ORIGINATION FORM

Proposed Revisions to a Standard Plans Index (Please provide all information — Incomplete forms will be returned)

Index Number: 700-110
Sheet Number (s): 1 of 1
Index Title: Mounting Exit Number Panels to Signs

INDEX
700-110

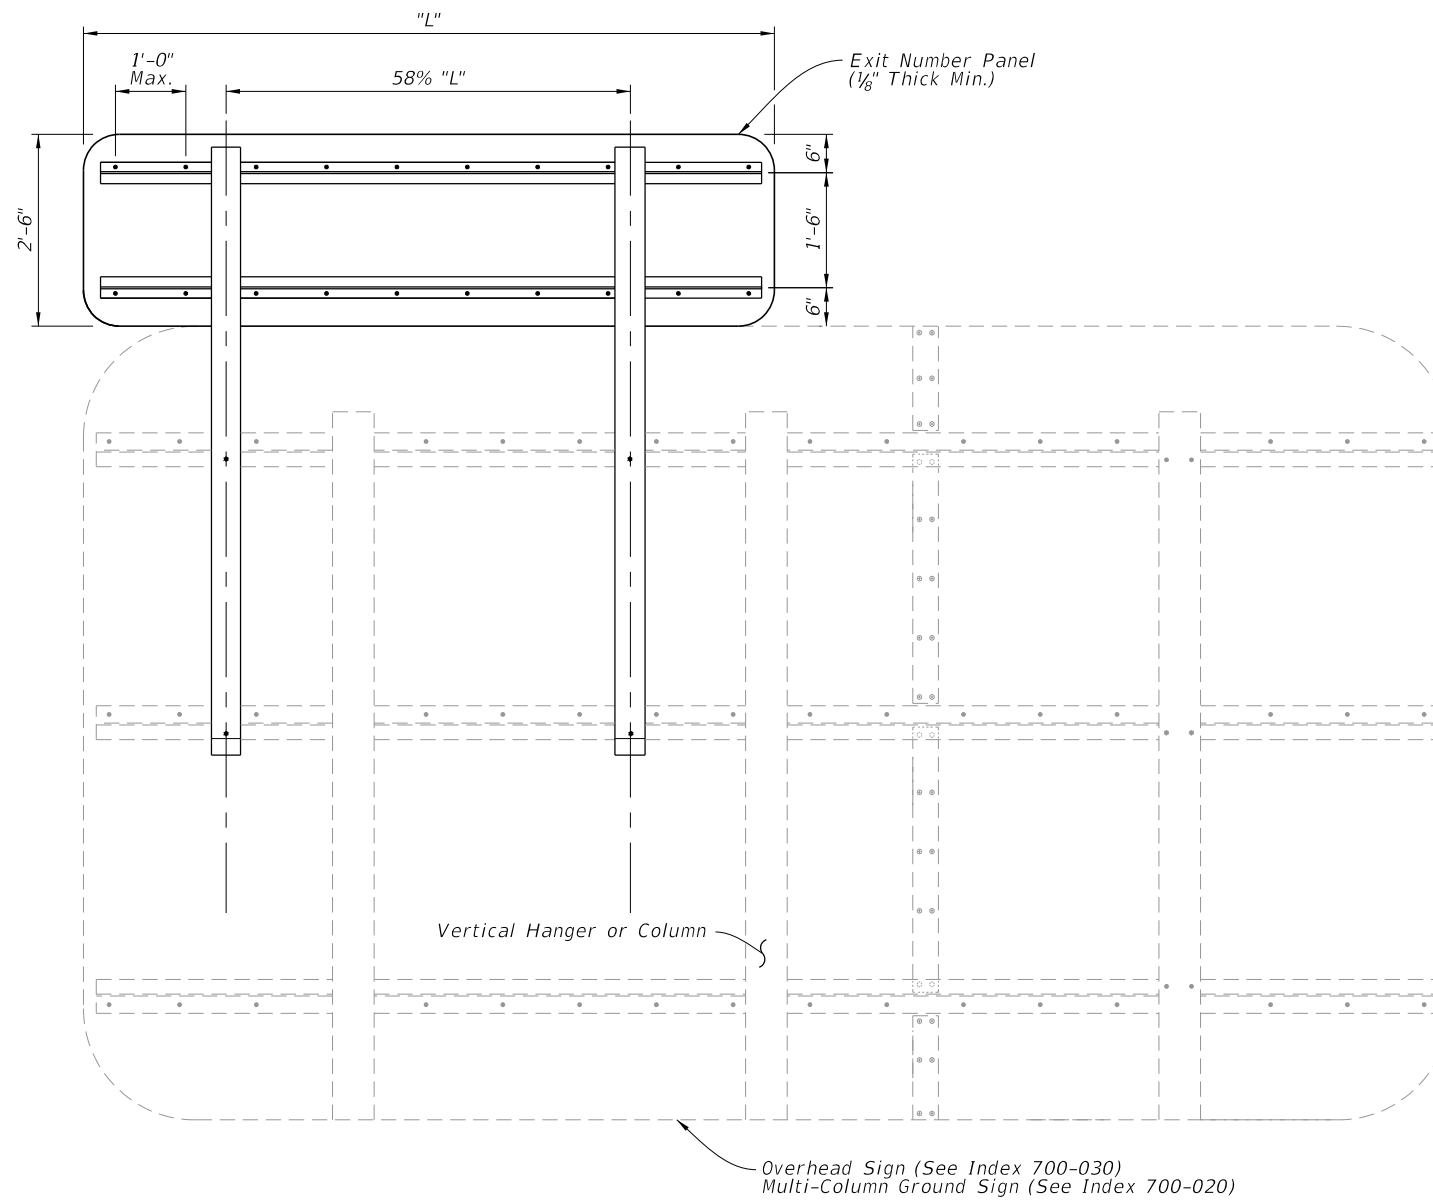
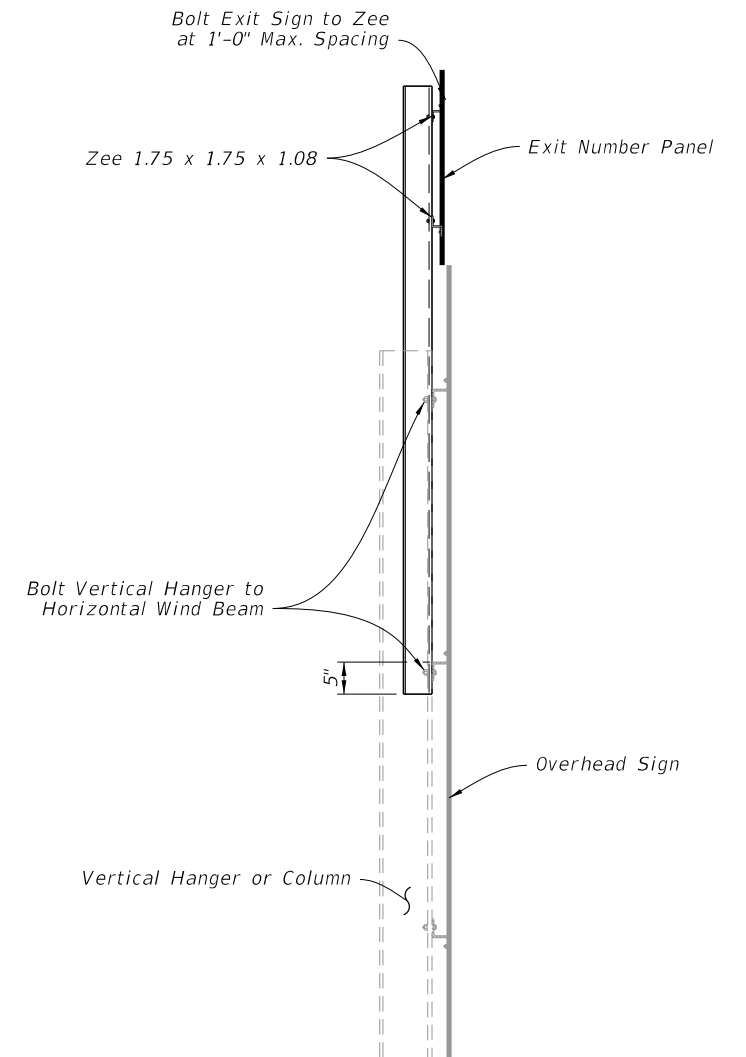
Change Note 2.B reference to ASTM B308 to ASTM B221 throughout Standard Plans as an administrative change.

ASTM withdrew B308 so we need to change it to ASTM B221

1. Work with Indexes 700-020 and 700-030.
2. **Materials (Aluminum):**
 - A. Sheets and Plates: ASTM B209 Alloy 6061-T6
 - B. Standard Structural Shapes: ASTM ~~B308~~ Alloy 6061-T6
 - C. Extruded Shapes: ASTM B221 Alloy 6061-T6
 - D. For Bolts, Nuts, and Washers requirements see Index 700-020 or 700-030.
3. **Fabrication:**
 - A. See sign layout sheet for dimension "L" and sign face details in the Plans.
 - B. Round all sign corners.
4. For right exits, install the Exit Numbering Panel to the top right side of the Highway Sign.
5. For left exits, install the Exit Numbering Panel to the top left side of the Highway Sign.

B221

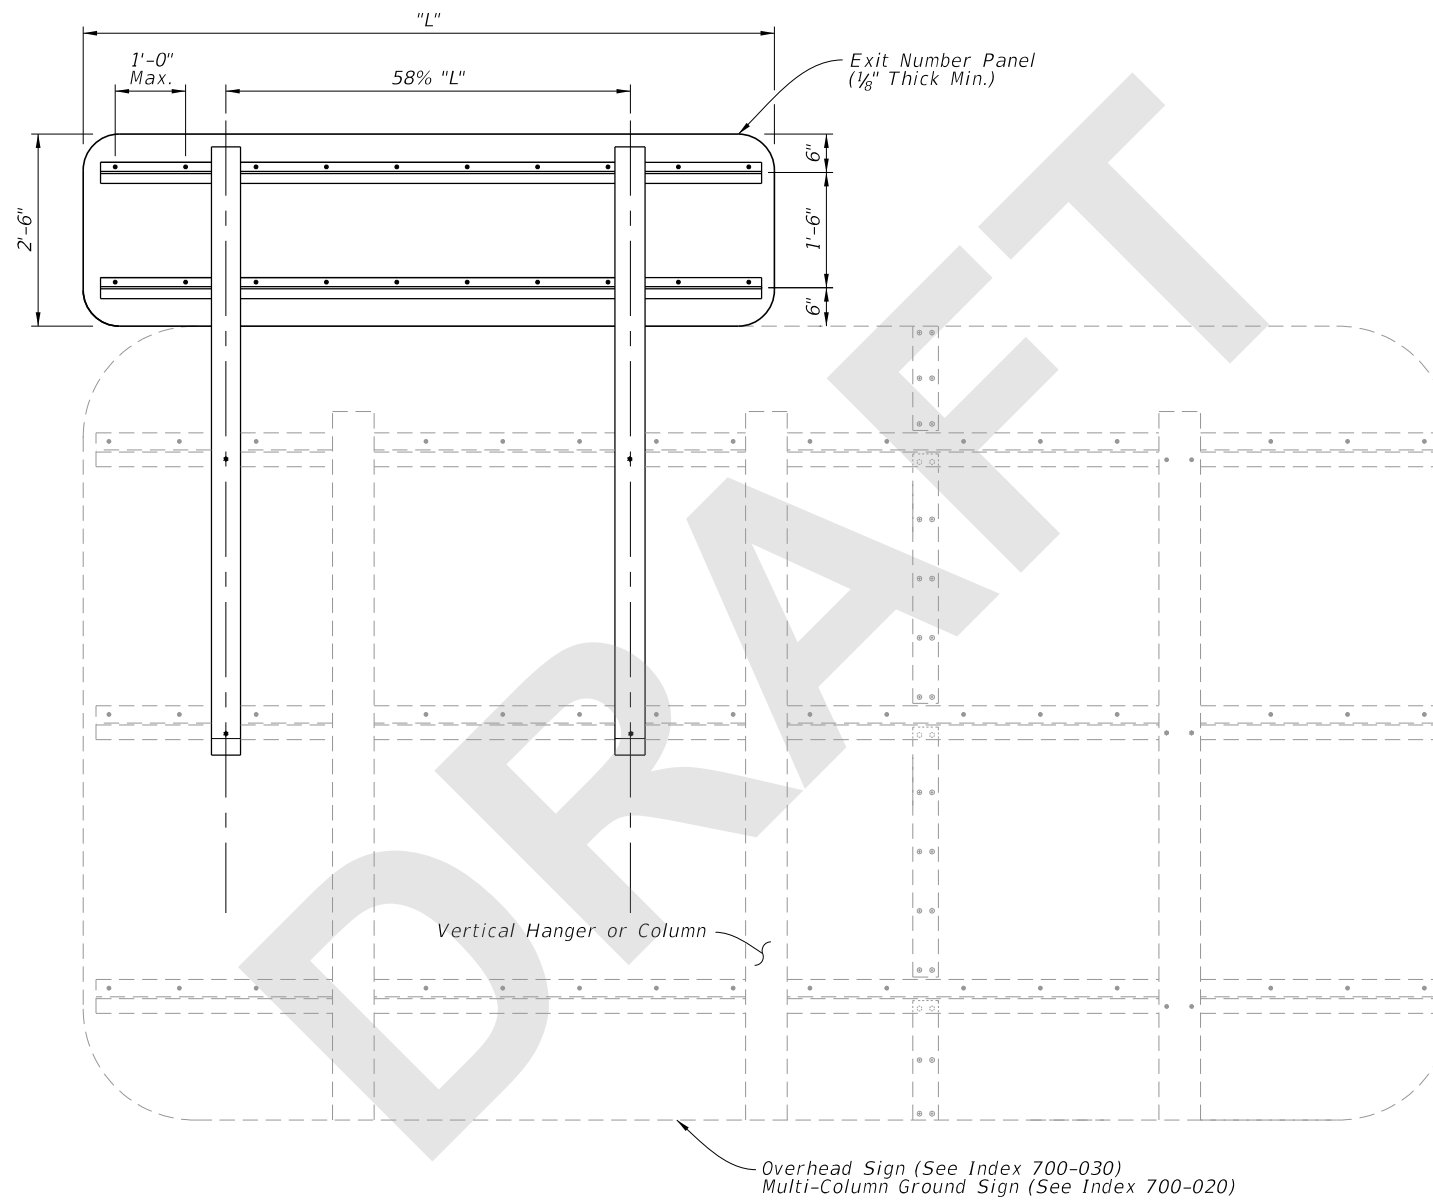
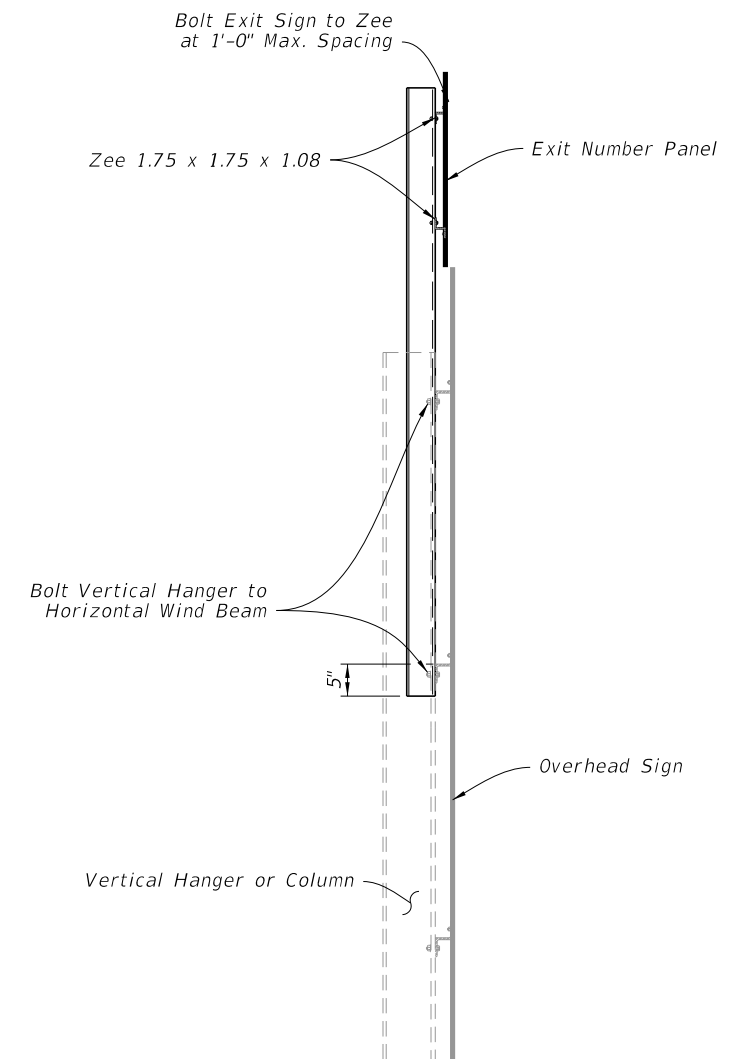
1. Work with Indexes 700-020 and 700-030.
2. Materials (Aluminum):
 - A. Sheets and Plates: ASTM B209 Alloy 6061-T6
 - B. Standard Structural Shapes: ASTM B221 Alloy 6061-T6
 - C. Extruded Shapes: ASTM B221 Alloy 6061-T6
 - D. For Bolts, Nuts, and Washers requirements see Index 700-020 or 700-030.
3. Fabrication:
 - A. See sign layout sheet for dimension "L" and sign face details in the Plans.
 - B. Round all sign corners.
4. For right exits, install the Exit Numbering Panel to the top right side of the Highway Sign.
5. For left exits, install the Exit Numbering Panel to the top left side of the Highway Sign.
